Project	<b>IEEE 802.16 Broadband Wireless Access Working Group</b> < <a href="http://ieee802.org/16">http://ieee802.org/16</a> >	
Title	<b>RS network entry procedure</b>	
Date Submitted	<b>2007-04-25</b>	
Source(s)	<p>Mike Hart, Yuefeng Zhou, Sunil Vadgama Fujitsu Laboratories of Europe Ltd. UK</p> <p>Masato Okuda Fujitsu Laboratories Ltd. Japan</p> <p>Hang Zhang, Peiying Zhu, Mo-Han Fong, Wen Tong, David Steer, Gamini Senarath, Derek Yu, Mark Naden, G.Q. Wang</p> <p>Nortel 3500 Carling Avenue Ottawa, Ontario K2H 8E9</p> <p>Sungjin Lee, Hyunjeong Kang, Hyoungkyu Lim Samsung Electronics</p> <p>Shyamal Ramachandran, Aparna Pandey, Eugene Visotsky, Philippe Sartori</p> <p>Motorola, Inc. 1064 Greenwood Blvd. Ste. 400 Lake Mary, FL 32746</p> <p>Kenji Saito, Takashi Inoue KDDI R&amp;D Laboratories Inc. Hikarino-oka 7-1, Yokosuka, Kanagawa 239- 0847, Japan</p> <p>Ozgur Oyman, Sumeet Sandhu, Nageen Himayat Intel Corporation 2200 Mission College Blvd. Santa Clara, CA 95054, U.S.A. Djamal-Eddine Meddour</p>	<p>Voice: +44 20 8606 4523 Fax: +44 20 8606 4539 <a href="mailto:mike.hart@uk.fujitsu.com">mike.hart@uk.fujitsu.com</a></p> <p>Voice: +1 613 7631315 <a href="mailto:wentong@nortel.com">we

Fig. xxx RS initialization overview

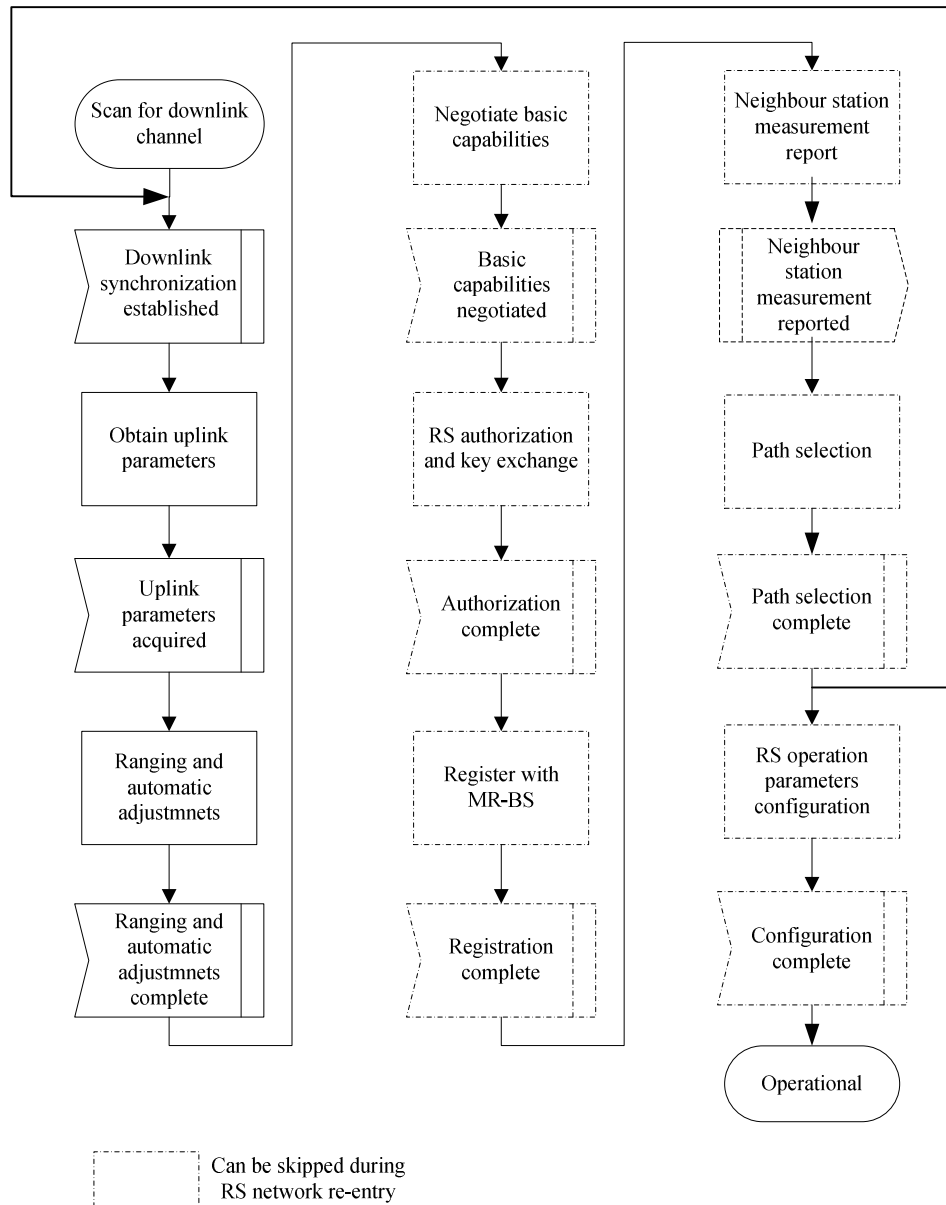
The procedure for initialization of an RS shall be as shown in Figure xxx. For the RS the stages g), h), i) and j) in the figure 55 are not required, for all other stages the RS shall behave in the same manner as an SS during network entry unless otherwise specified in the subclauses of 6.3.9. The more detailed finite state machine representations of the individual sections (including error paths) and the timeout values shall be the same as those provided for the SS, unless otherwise specified.

[Insert the following figure]
